APPENDIX A

**Draft Local Plan
(second deposit)
Policies L13 and L14**

B1. DRAFT LOCAL PLAN (FIRST DEPOSIT) COMMENTS

Job Title
WILTS AND BERKS CANAL
ABINGDON FEASIBILITY STUDY

Proposals Map: Eastern Vale and Abingdon Inset

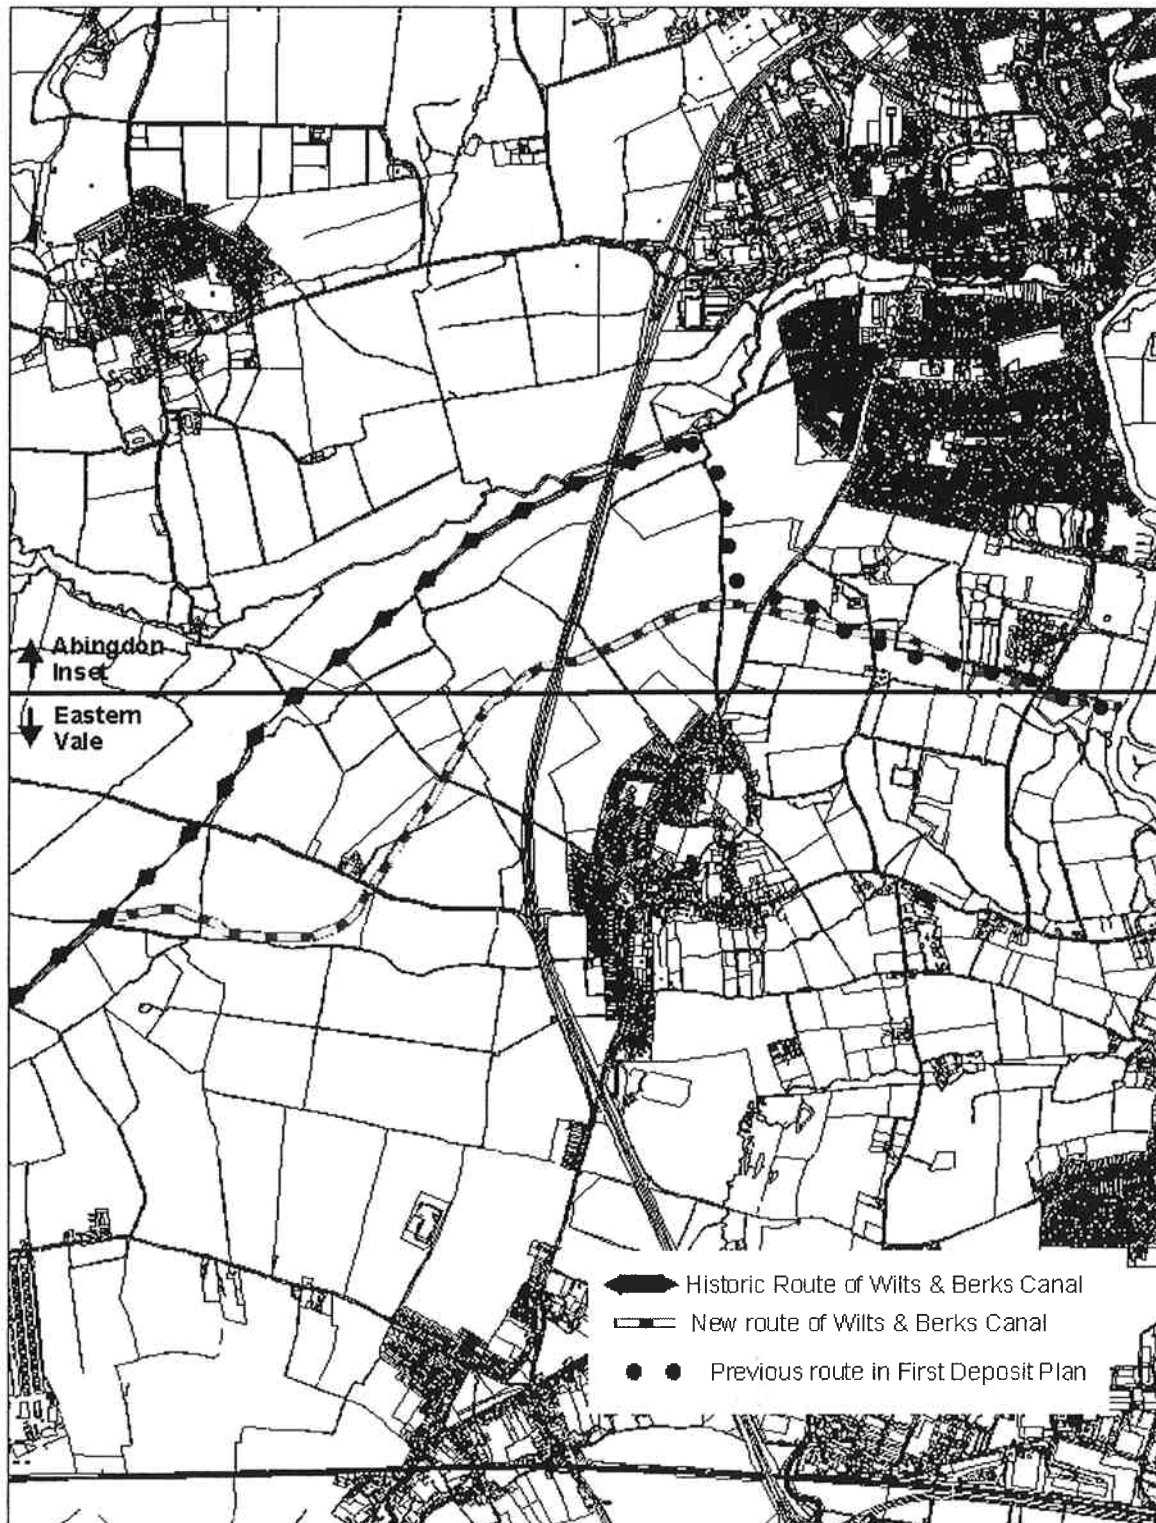
DEVELOPMENT WHICH WOULD PREVENT THE IMPLEMENTATION OF THE PROPOSED NEW ROUTE FOR THE CANAL SOUTH OF ABINGDON AS SHOWN ON THE PROPOSALS MAP WILL BE REFUSED.

Georgie Cook Thames Water	L14	Opposed because of impact on discharge at Abingdon Sewage Works. Possible increase in complaints about water odour and litter if canal opens.	Objects

**Environment Agency/
Halcrow Modelled
Floodplain at River Ock**

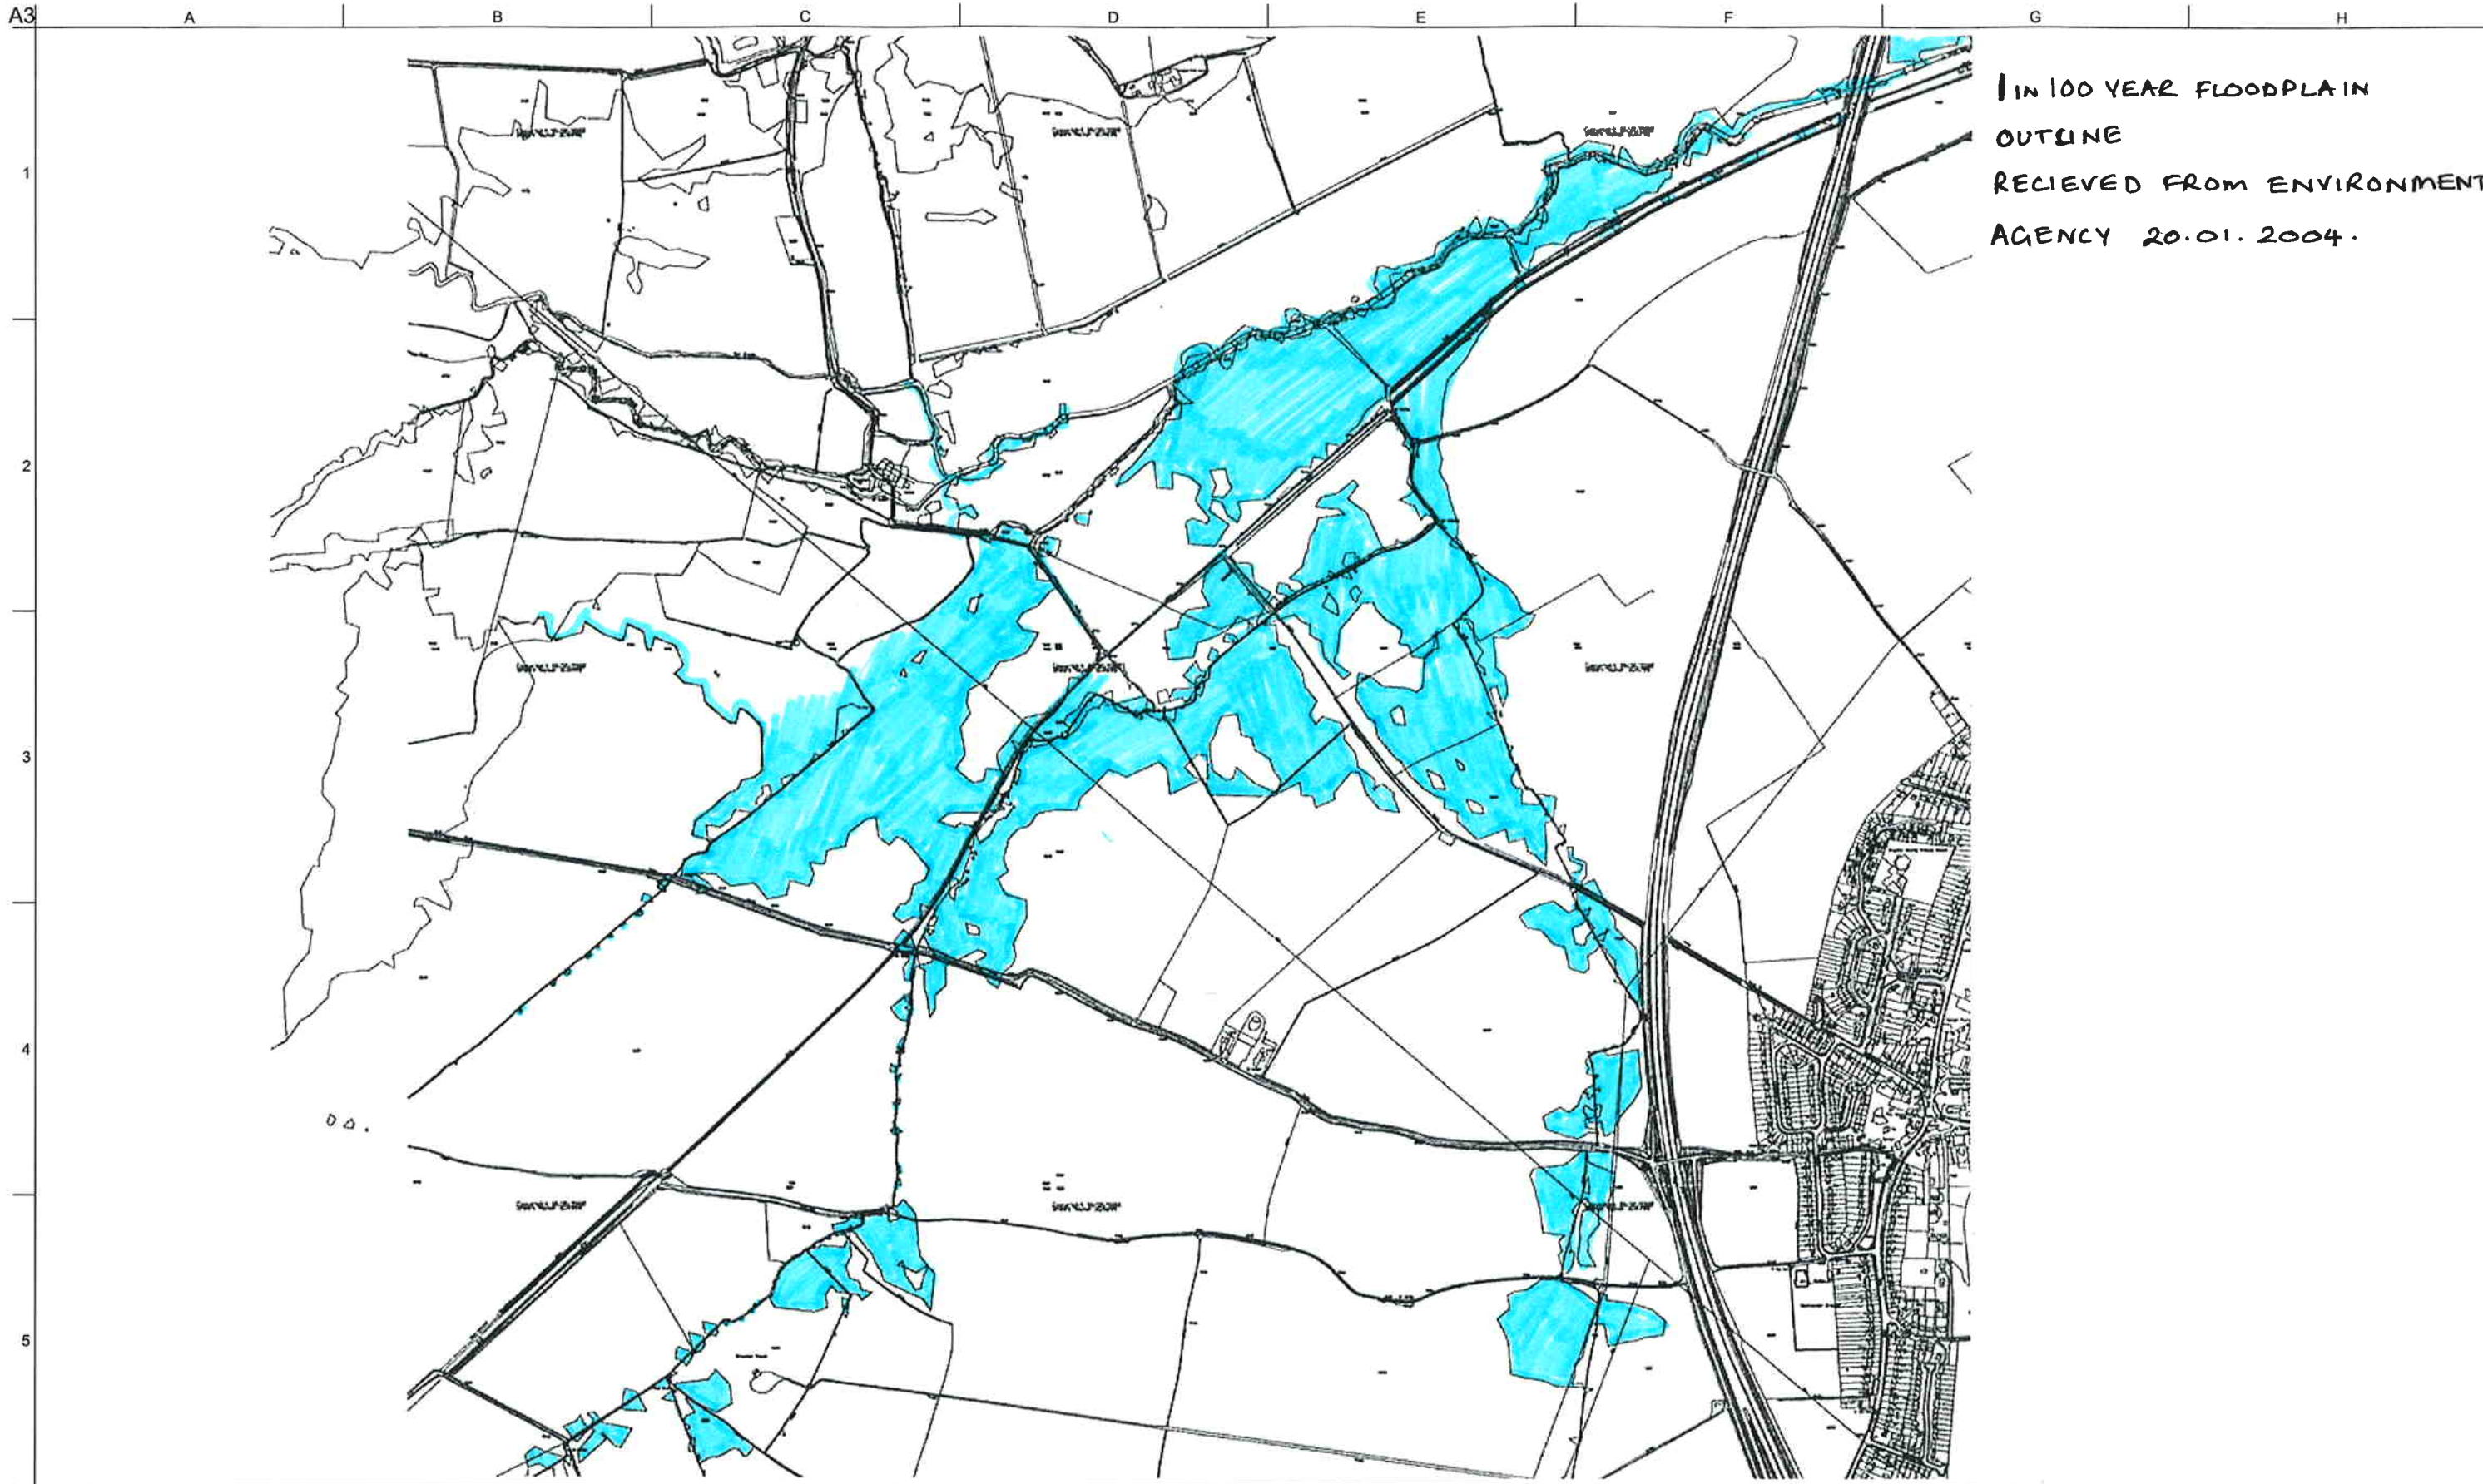
Consultee Response
<p>The routes passes through indicative floodplains of the River Ock and River Thames. The Agency has recently undertaken hydraulic/hydrological modelling of these watercourses, in the near future, 1 in 100 year flood water levels will be available to utilise in the detailed design.</p> <p>Technical information or a flood risk assessment (FRA) must be provided with any planning application, to demonstrate that, the proposed development does not increase the flood risk to people and property on the site and in the surrounding area. The Agency resists all development or works within the floodplain that results in a loss of flood storage capacity or impede flood flow routes. Any losses identified as part of these works must be fully compensated for on a level for level, volume for volume basis.</p> <p>As described in paragraph 30 of PPG25 "Development and Flood Risk". No inappropriate development should take place within the floodplain and the applicant should undertake a flood risk assessment (FRA) as recommended by PPG25.</p> <p>Under the terms of the Water Resources Act 1991 and the Land Drainage Byelaws 1981, the prior written consent of the Environment Agency is required for any proposed works or structures in, under, over or within 8 metres of the brink of the River Ock, Sandford Brook, River Thames main river. Contact David McKnight on 01491 828303 for further details.</p> <p>We are aware of several watercourses effected by this proposal, we therefore advise that:</p> <p>(1) they should not be culverted; and</p> <p>(2) a buffer zone is left on either side of any watercourse, and</p> <p>(3) culverted watercourses should not be built over, but should ideally be opened up and made a feature of the site.</p>

The route passes through indicative floodplains of the River Ock and River Thames, therefore having the potential to impact upon flood storage capacity and alter existing flood flow routes. The revised routes for the canal would still pass through sections of the 1 in 100 year flood plain of the River Ock and sections of the 1 in 5 year flood plain of the River Thames. The Agency resists all development or works within the floodplain that results in a loss of flood storage capacity or impede flood flow routes. Any losses identified as part of these works must be fully compensated for on a level for level, volume for volume basis.

In accordance with the advice offered within PPG25 the Agency considers it necessary for the applicant to submit an appropriately detailed Flood Risk Assessment (PPG 25, Appendix F) prior to submission of any planning application. It would be in the best interest of the applicant to discuss the scope of the Flood Risk Assessment in advance with the Agency before submitting the same to the local planning authority.
